ADDENDUM NO. 1

Wayne High School Campus Improvements

Fort Wayne Community Schools (FWCS)

November 7, 2025

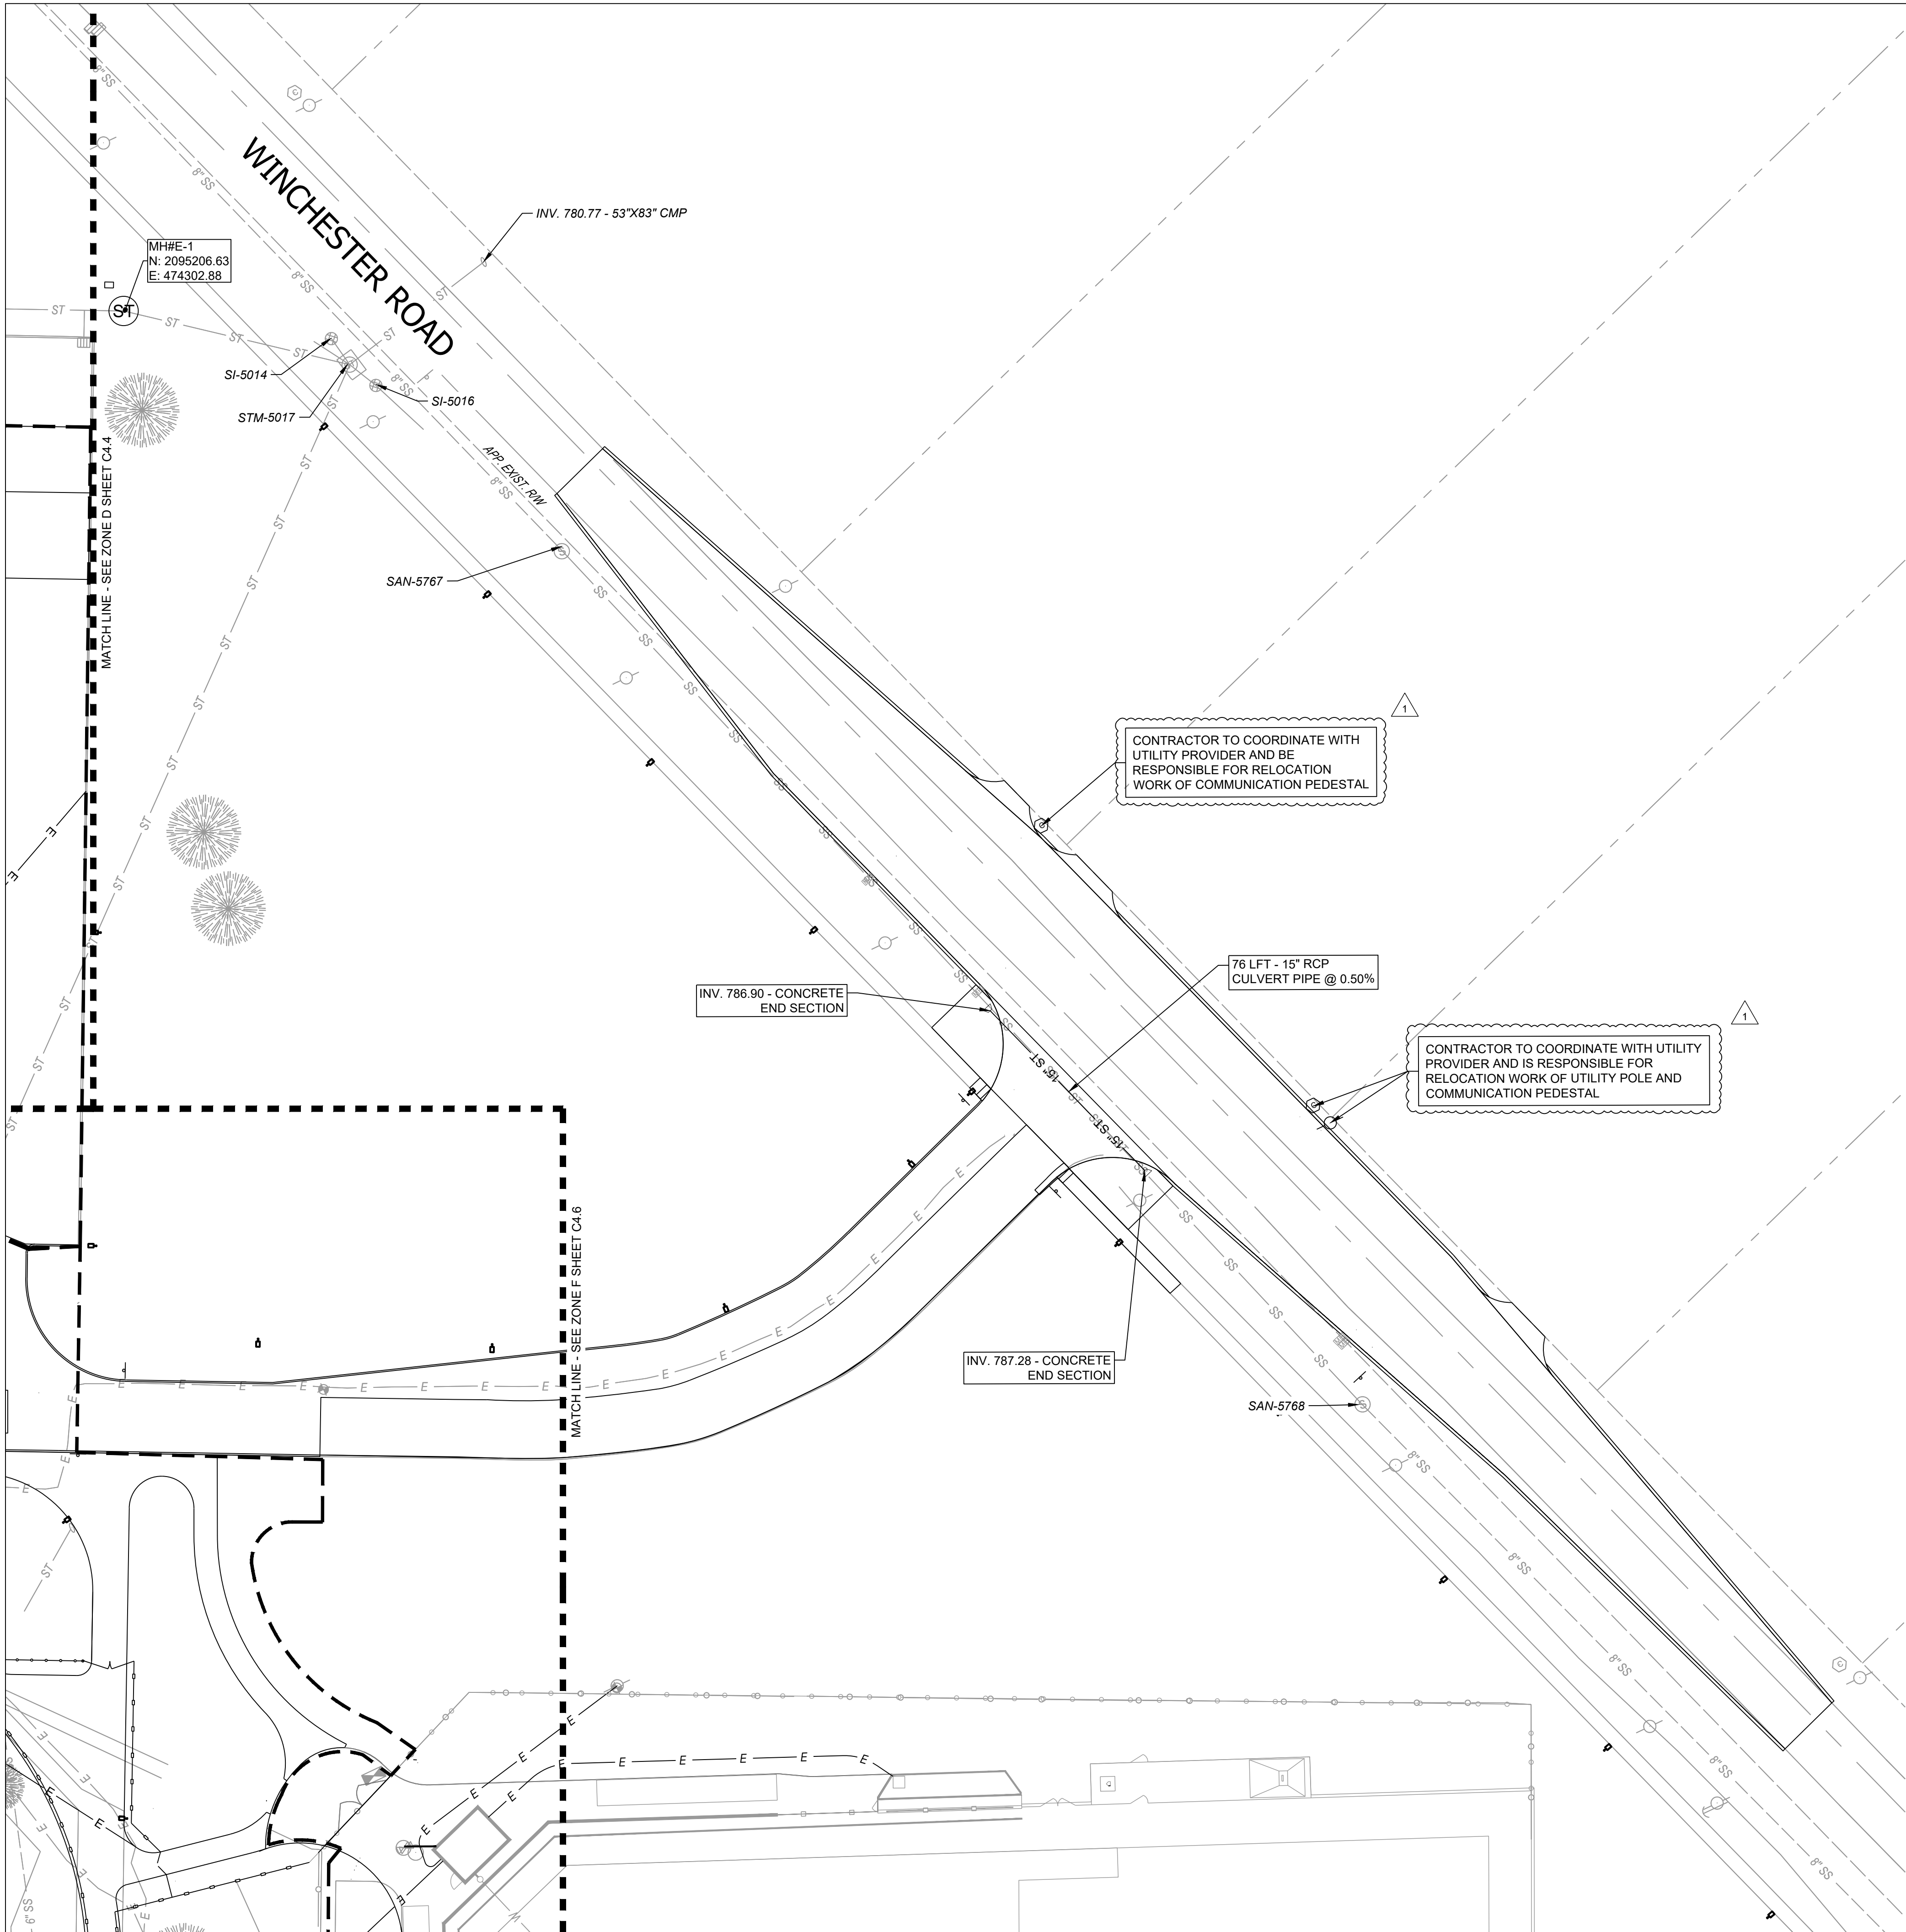
ADDED: MH#E-1 maximum treatment flow and internal bypass requirement on Proposed Storm Structure Information Table to comply with Allen County Surveyor’s Office stormwater comments.

REVISED: Contractor notes on utility coordination.

ADDED: Proposed Lighting Improvement symbol to Legend.

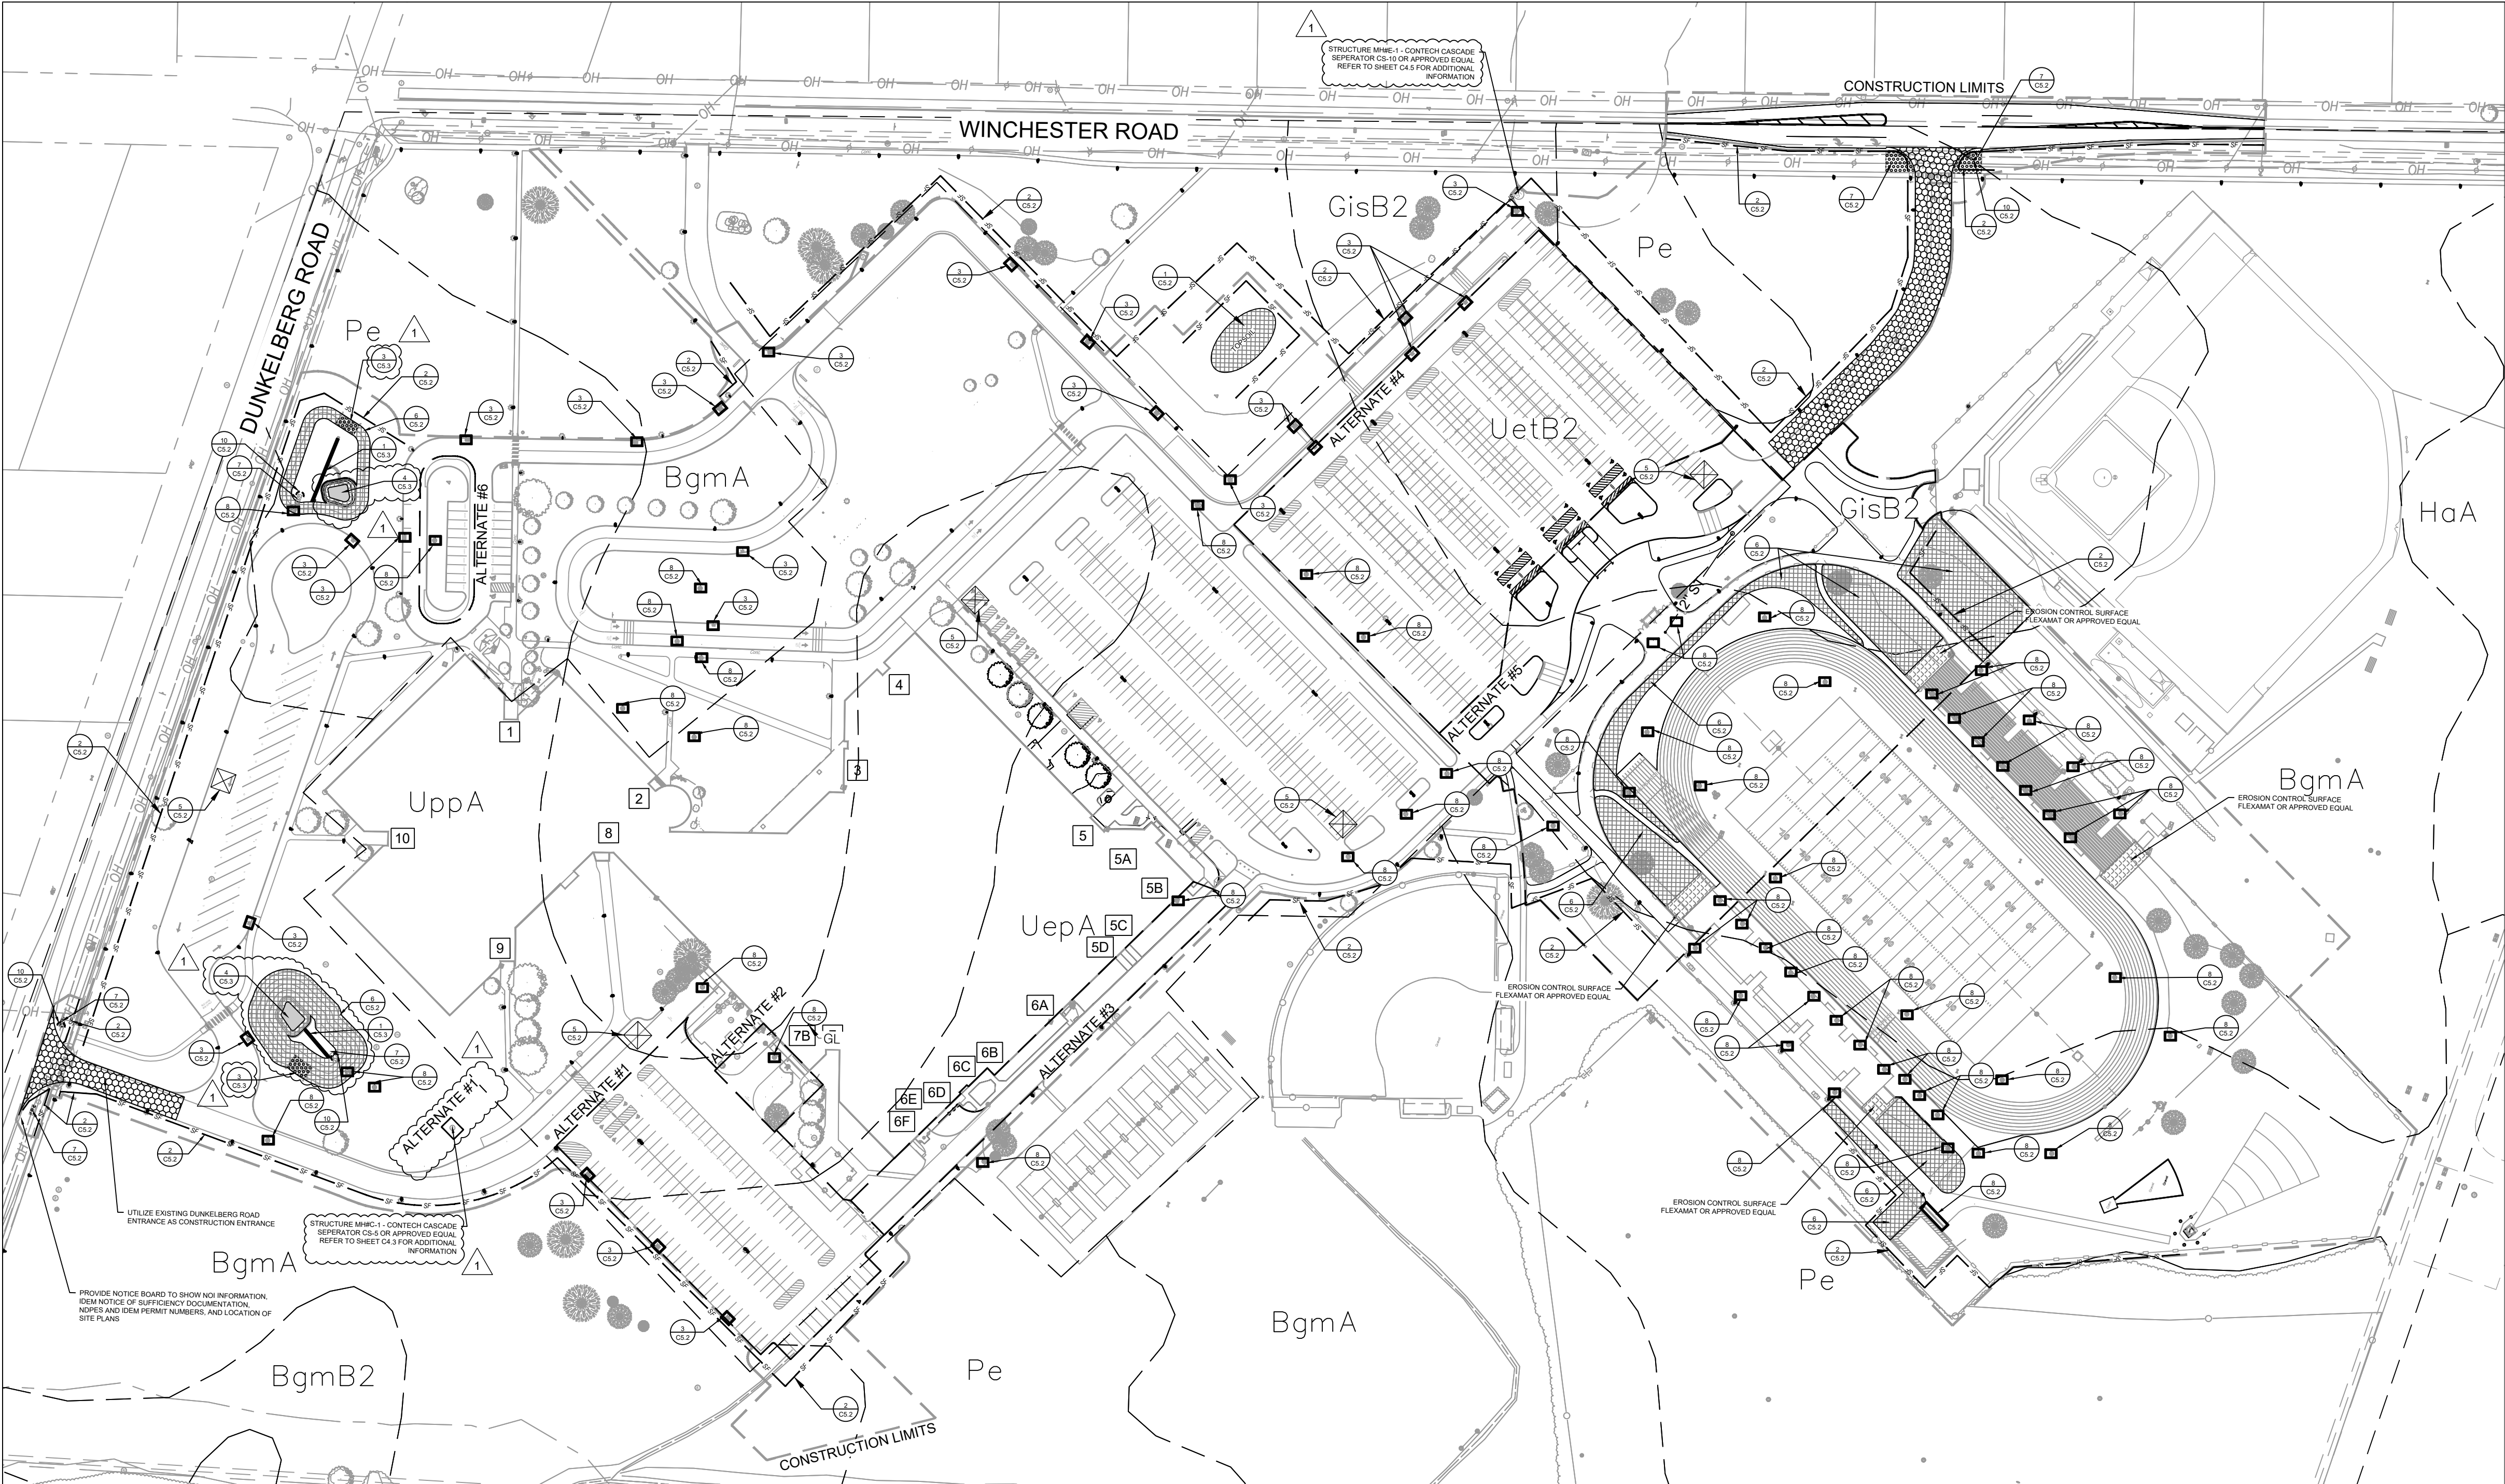
ADDED: Water Quality Unit call outs for MH#C-1 and MH#E-1 to comply with Allen County Surveyor's Office stormwater comments.

ADDED: Micropool callout on Erosion Control Plan.

REVISED: Erosion Control Blanket area per addition of micropools to detention basins.

ADDED: Emergency Spillway erosion control mats to detention basins to comply with Allen County Surveyor's Office stormwater comments.

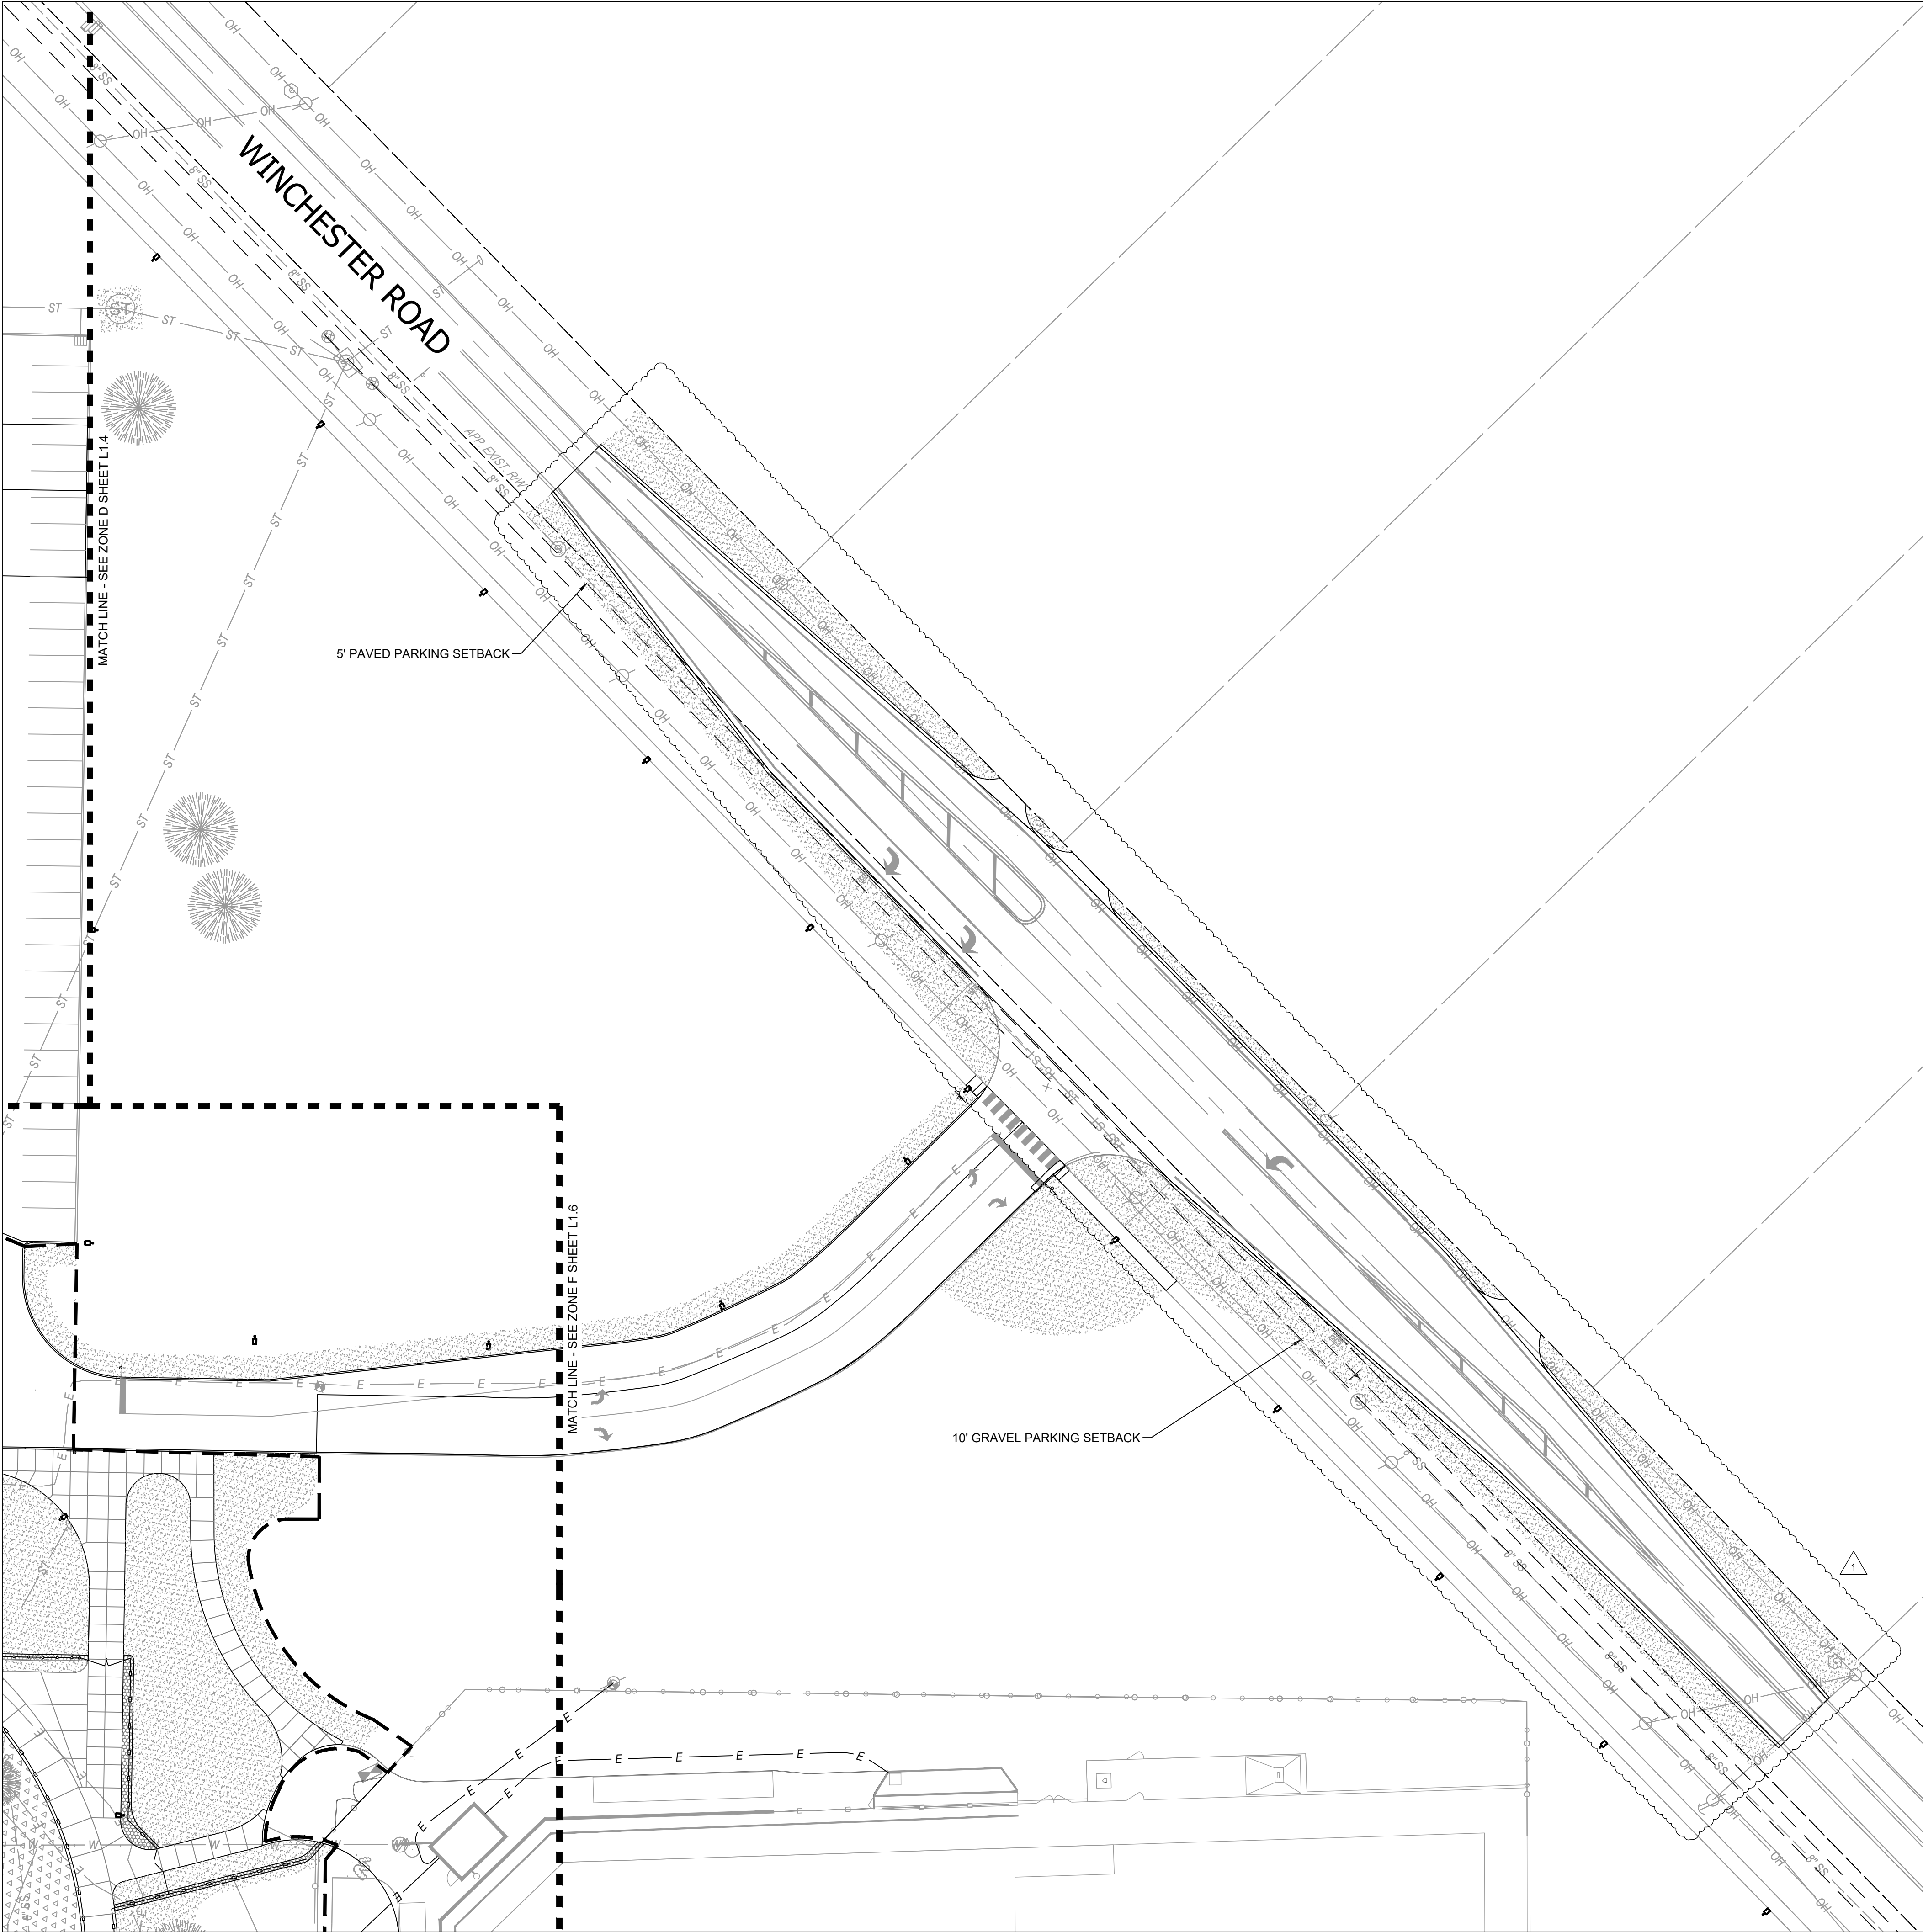
34. Plan Sheet L1.5 – Site Landscape Plan – Zone E
REVISED: Seeding areas along Winchester Road.
